Lloyd's Register of Shipping.

Ship's Name S/S "TEMPLE PIER"

Official No. 160509

Memorandum of alterations reported since ship was surveyed for assignment of Load Lines
in GENOA - NOVEMBER 1946

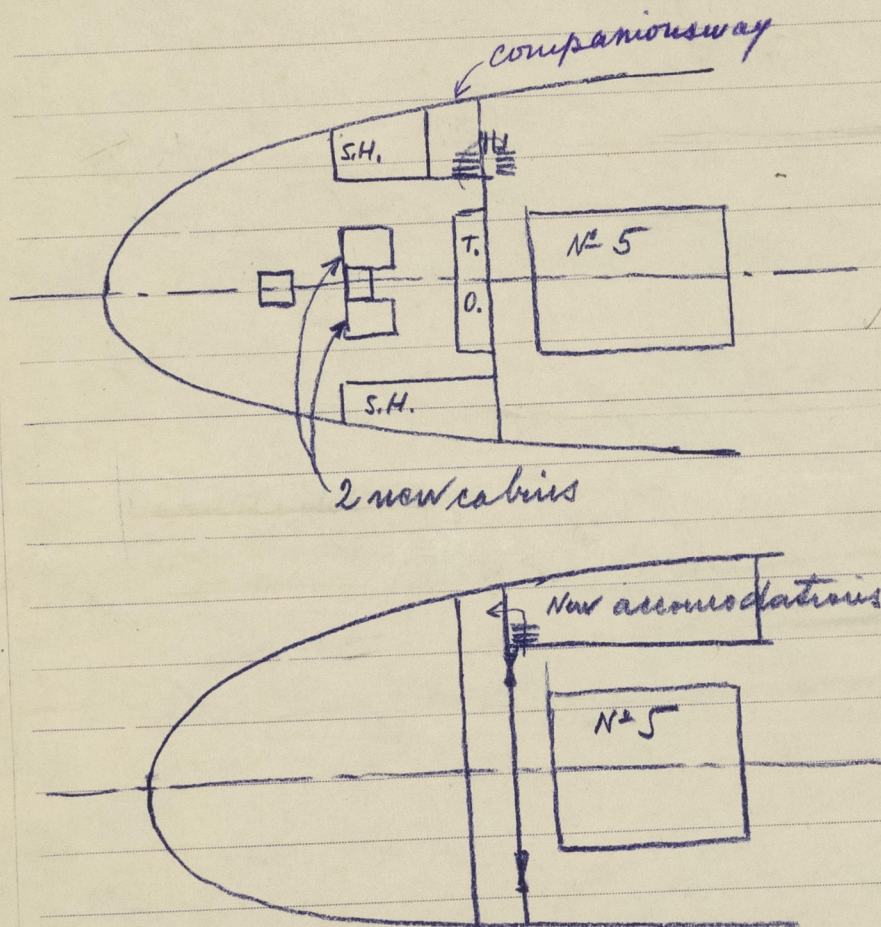
Additional crews quarters fitted in shelter tween deck on port side as shown in sketch. Companionsway built leading from port side after deckhouse to accommodations. Door to the same on upper deck constructed of teak and operating both sides. Sill 18".

9 additional sidescuttles 12" \square fitted in the above accommodations, properly constructed with strong

deadlights. Deckhouse abaft tonnage opening enlarged to provide 2 cabins.

One new ventilator fitted on shelter deck aft leading to shelter tween deck. Coaming 31" X 40.
Closing - wood plug & canvas cover.
